Battery Charger Section

Title: Power_Sheet.SchDoc	
File: Internal Battery Charger - v1.0.PrjPcb	
Date: 28/11/2024	Page Num: 1
Drawn By: Huzaifa Ali	Page Total: 1

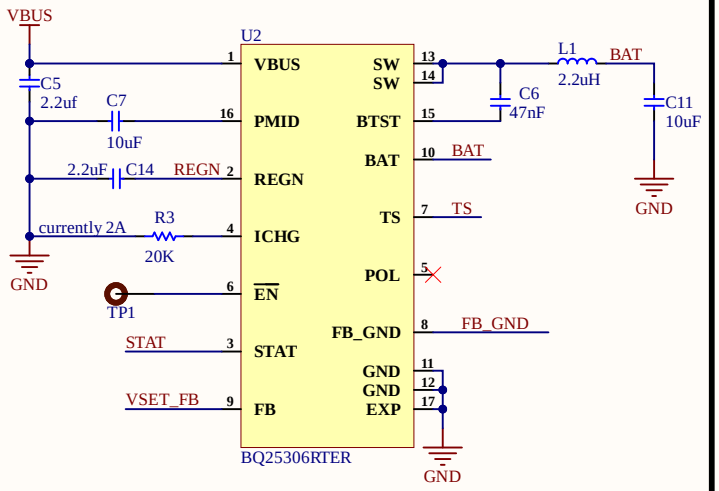
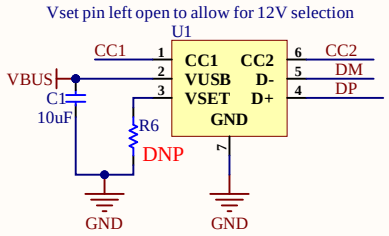
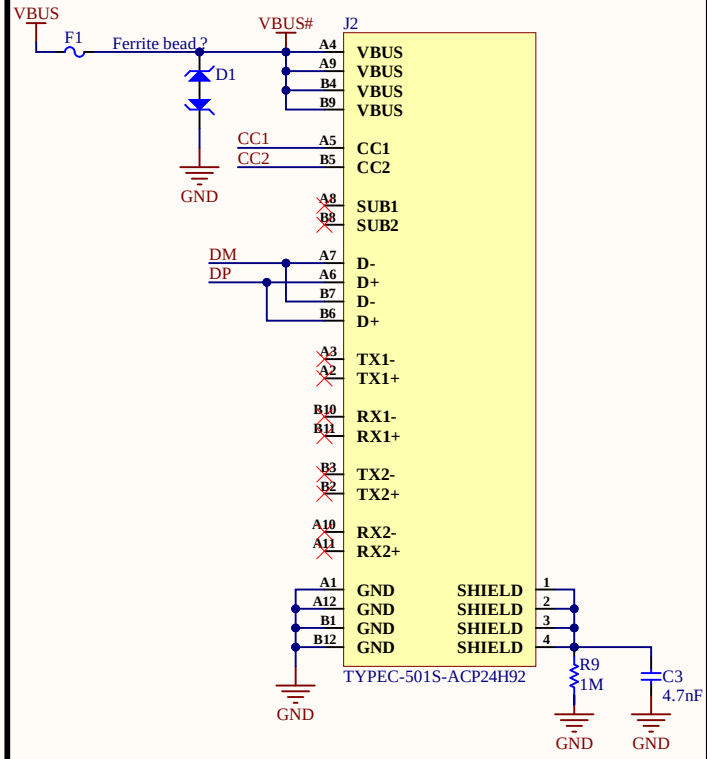
currently Led current at 3mA

Enable ki logic dekhni hai kia aesa kry k input agr 9v or 12v sy ziada ho to enable on ho ?
